All Purpose Building Permit Application

BUILDING PERMIT REPORT

DATE: 21 June 2001 ADDRESS: 46 Rumrose Lane CBI: 350-0-004

REASON FOR PERMIT: To Construct deck and screen room

PROPOSED DECK + SCREENED ROOM ON THE TURNER HOUSE
46 PRIMROSE LANE

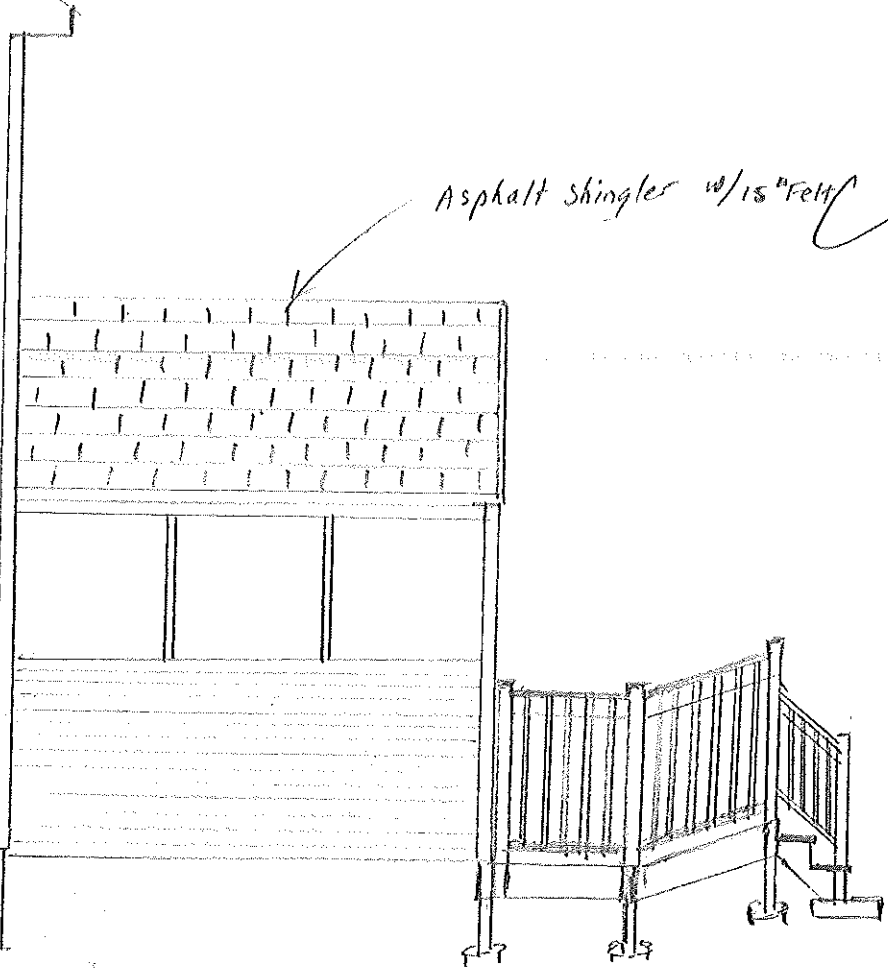
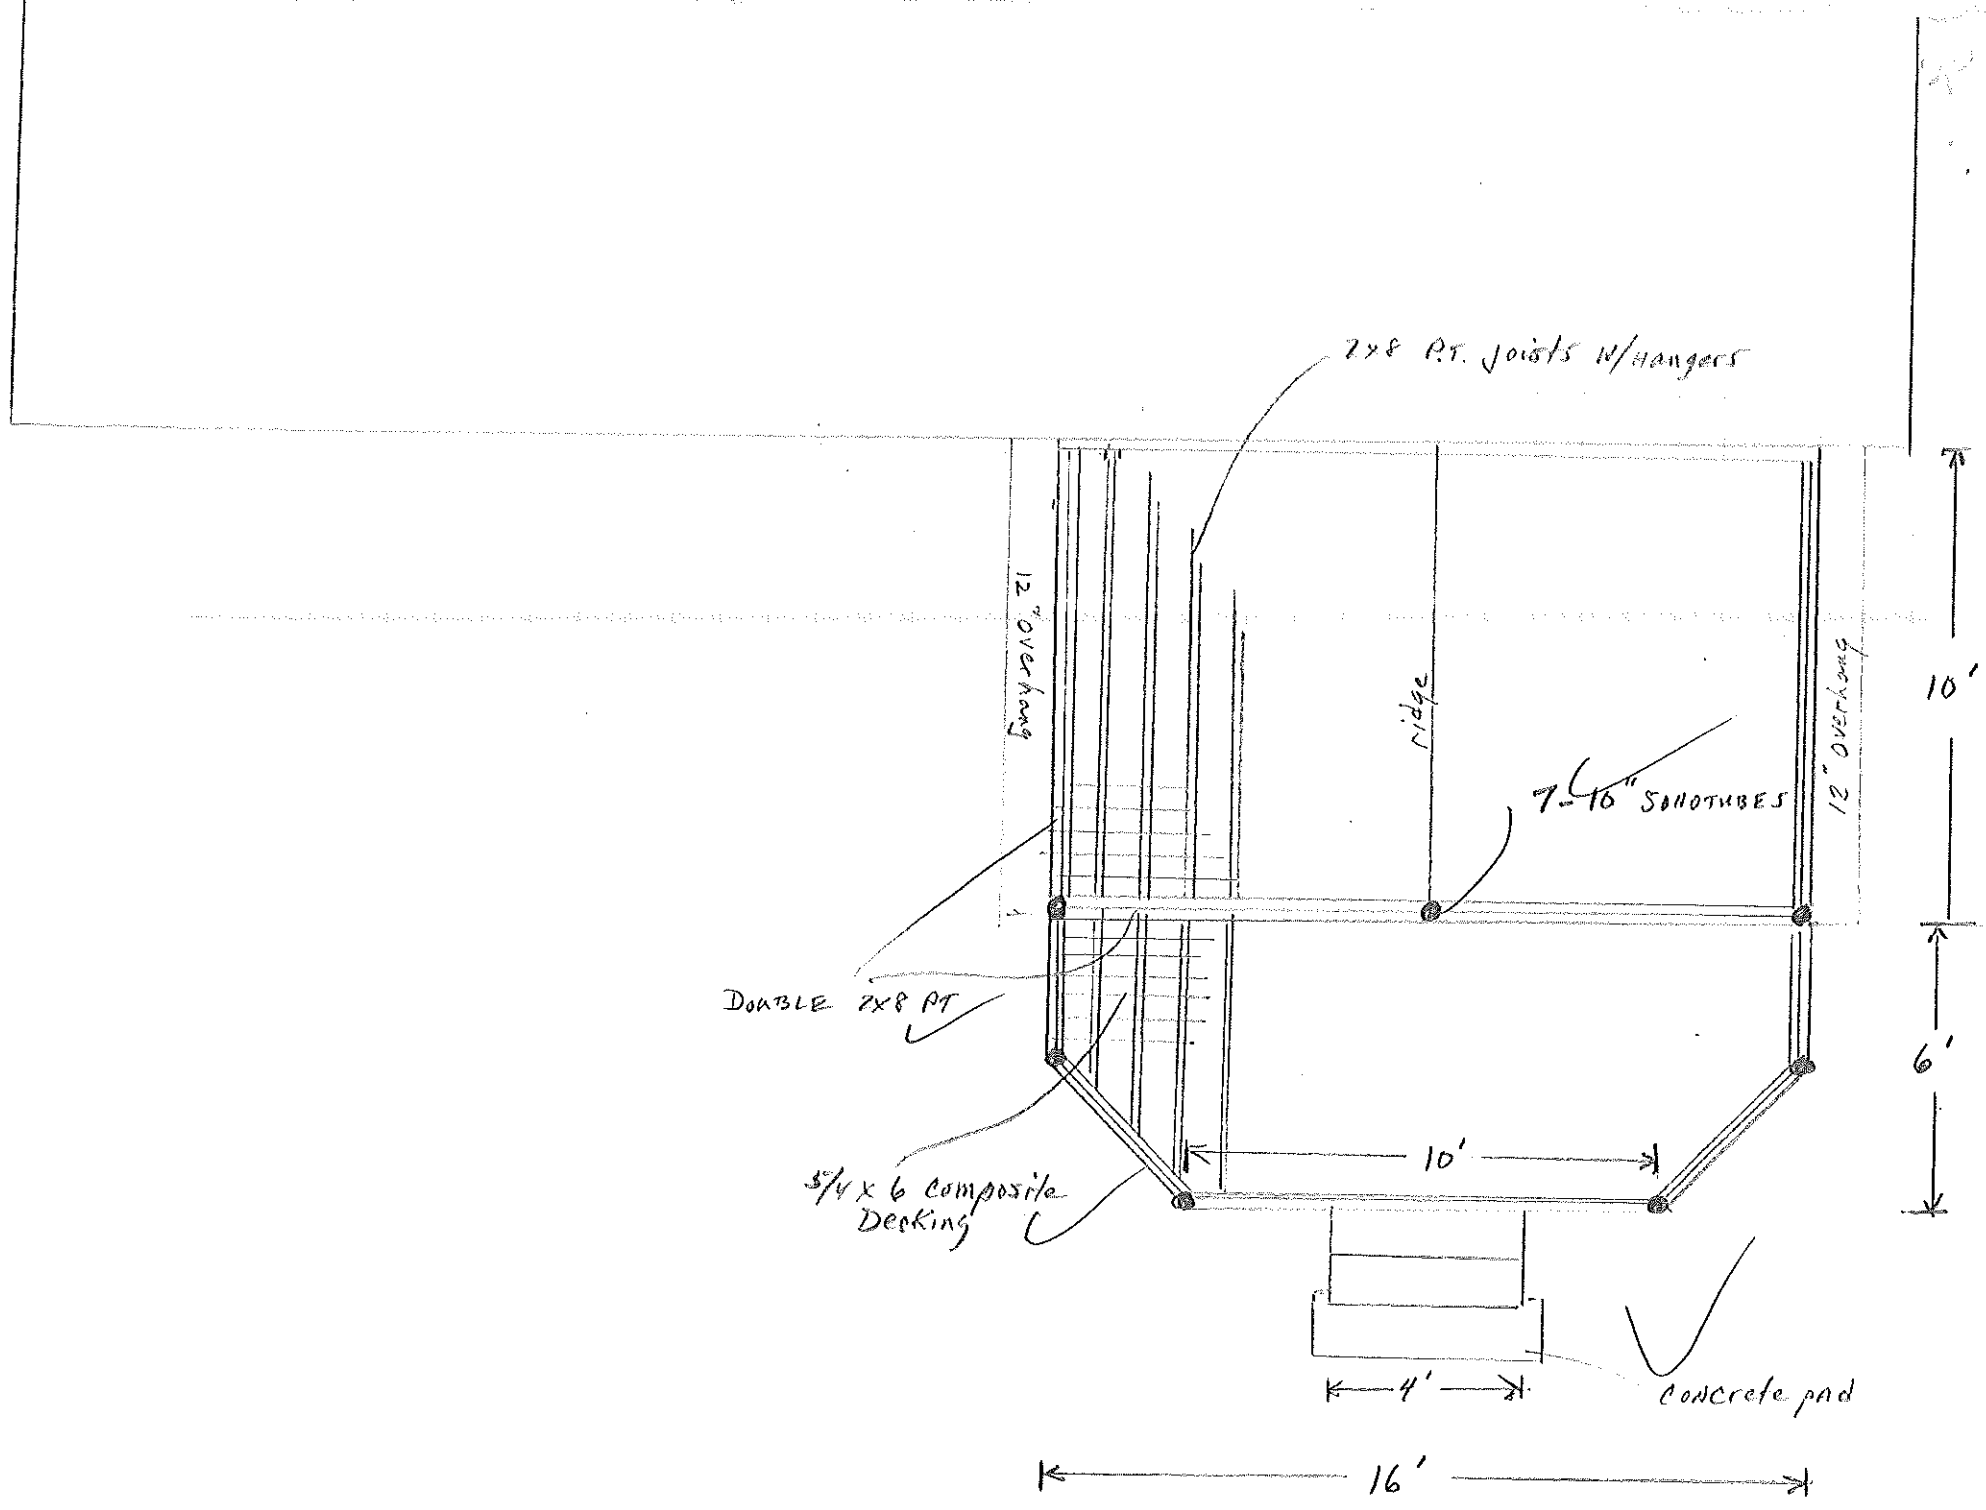
Flashing
14x6.3.10

36" can be
42" RAILS
w/ BALLUSTERS
3 1/2" apart
